ADDENDUM NO. 5

HVAC & CONTROLS REPLACEMENT/ADDITION AT NINE (9) SITES: BARRANCA, BEN LOMOND, CYPRESS, GROVECENTER, MANZANITA, MERWIN, MESA, ROWLAND, AND WORKMAN ELEMENTARY SCHOOLS RFQ/RFP #22-23-105

January 13, 2023

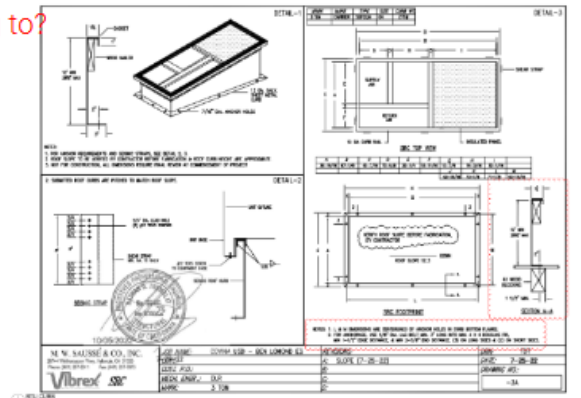
Question 5: The drawings do not contain framing or attachment details for the new RTU equipment curbs, keynotes state to attach new mechanical equipment to existing curbs, and Barranca is the only school with existing roof top equipment.

The RFI is not clear. What keynote are you referring to?

Refer to M.W.Sausse drawings for new 3-ton RTU curb detail-3. See attached as reference.
